\_\_\_\_\_ASSESSMENT OF ISSUES AND ALTERNATIVES  
ASSOCIATED WITH PROPOSED  
GROUND WATER DEVELOPMENT NEAR  
GRAND CANYON NATIONAL PARK  
AT TUSAYAN, ARIZONA

-DRAFT-

National Park Service  
Water Resources Division • Fort Collins, Colorado  
September 17, 1993

Figure 1. A conceptualization of the regional aquifer, indicating principal fracture zones (from Errol L. Montgomery and Associates, Inc., 1993).

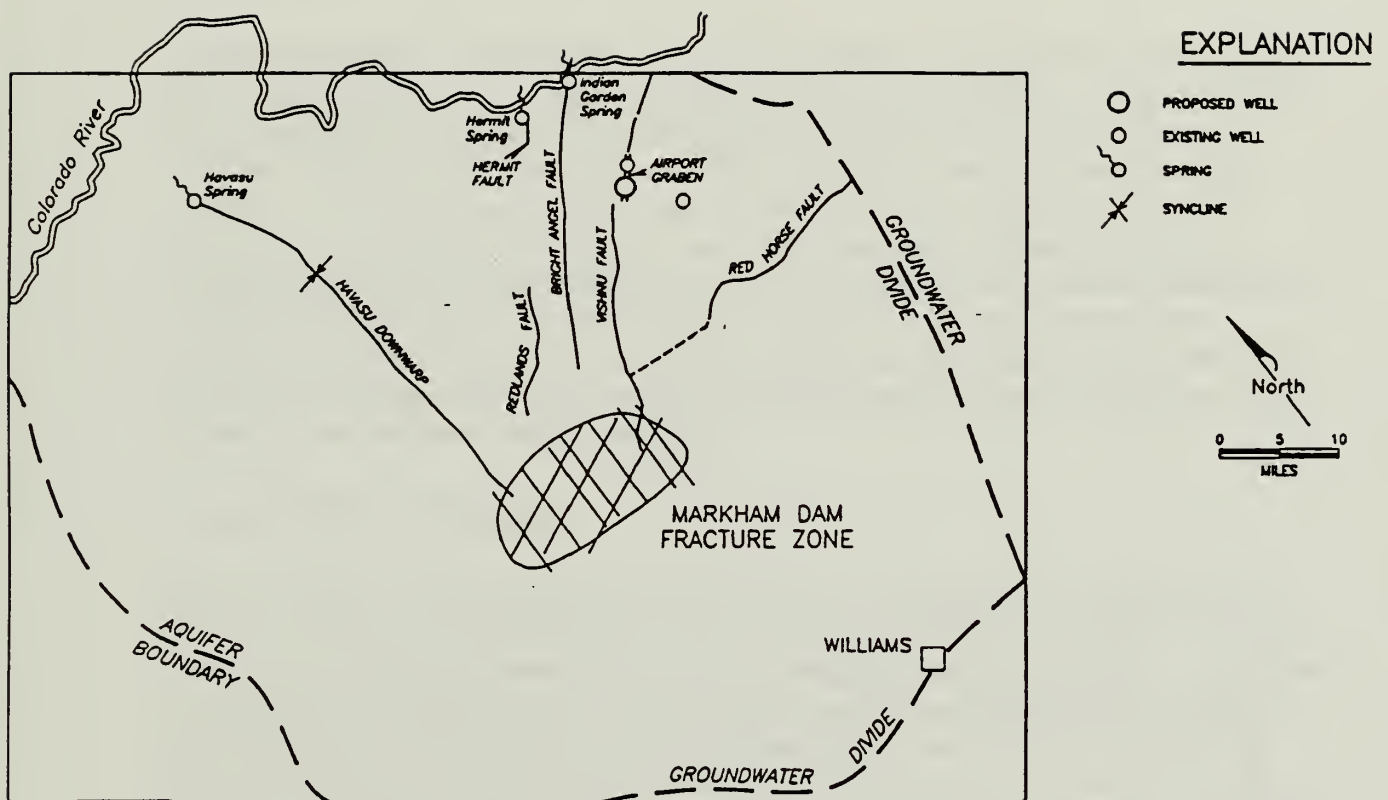
The descriptive model of the aquifer system shows the Havasu Downwarp and the Vishnu and Redhorse fault systems as interconnected with the Markham Dam fracture zone, but the Bright Angel and Redlands faults as disconnected. The basis for this assumption is not provided and its validity cannot be confirmed. However, as discussed below, the accuracy of this assumption may be important in defining the response of the springs to pumping elsewhere in the aquifer.

The Havasu Downwarp is described by Metzger (1961) and interpreted by Montgomery and Associates, Inc. as having large transmissivity and storativity and as the likely source for the large spring at Havasu. The "Markham Dam Fracture Zone" is described in the Montgomery and Associates, Inc. report as a large zone of recharge and water storage for the regional aquifer. Older reports do not mention this large reservoir, but it is also very deep and possibly beyond the limits of previous exploration. Interconnection of this reservoir with springs and the hydrogeologic function of faults has not been previously documented. Again, both the existence of this important recharge/reservoir zone and the existence of an effective hydraulic connection to the Vishnu fault and Airport Graben, is difficult to validate but critical to the prediction of aquifer response to ground water pumping.

Both Hermit and Indian Garden springs are described as associated with fracture zones that are not interconnected with either the Vishnu Fault, or the Airport Graben. Again, the validity of this assumption cannot be confirmed. However, it is very probable that, in addition to the primary fracture zones depicted in the descriptive model of the regional aquifer, there exist hundreds of secondary fractures and solution cavities. It may be impossible to meaningfully characterize secondary fracturing in the regional aquifer or to account for its hydraulic effects within the context of a regional ground water model. However, secondary pathways may be very important in evaluating aquifer response to ground water pumping in specific locations; and especially in locations assumed to be poorly connected hydraulically, to primary zones of water storage and movement.

Assumptions which necessarily went into the characterization of flow paths within the regional aquifer cause concern that the model as presently constructed could misrepresent the potential impacts of pumping on Grand Canyon Springs. Probably the most significant of these assumptions is that Hermit and Indian Garden springs are associated with faults which are not connected to the Vishnu Fault, the Airport Graben or the Markham Dam fracture zone. The assumed lack of effective hydraulic connection between these springs and the Airport Graben serves to "force" the model to draw water from the Vishnu Fault and Markham Dam areas, while minimizing drawdowns in the Bright Angel and Hermit faults.

The second important assumption is that the Airport Graben/Vishnu Fault zones are effectively connected to and recharged by the reservoir assumed to underlay the Markham Dam fracture zone. This assumption is critical for three reasons. First, it permits effective recharge to the Airport Graben during pumping, thus enabling pumping to continue indefinitely at 300 gpm. Second, it minimizes the amount of drawdown in the Airport Graben caused by pumping, further minimizing impacts to local springs. Third, it draws most recharge water from the Markham Dam region; water that primarily is destined to discharge at Havasu Springs.

A third critical assumption is that the Markham Dam fracture zone is, in fact, a significant recharge area for the regional aquifer, and that a significant reservoir of water underlies this zone, and that the reservoir currently is being recharged by infiltration of precipitation. It is the existence of this large fracture zone, in combination with the assumed efficient hydraulic connection to the Airport Graben, which largely causes the model to predict a minimal impact to Hermit and Indian Garden springs, while drawing most recharge water from the Markham Dam/Havasupai Downwarp/Havasupai Spring area.

A "worst case" aquifer conceptualization scenario from the standpoint of potential pumping impacts to park springs should be constructed and modeled. At a minimum, fracturing in the Redwall/Mauv Aquifers should be redefined to show hydraulic connection via secondary fracturing between the Bright Angel Fault and the Airport Graben/Vishnu Fault. Also, secondary fracturing between the Bright Angel Fault and the Markham Dam fracture zone should be assumed to exist. Given a modified conceptualization of the aquifer, the model should be calibrated for the pre-pumping condition and run for pumping locations at Tusayan, and both 10 and 20 miles south of Tusayan.
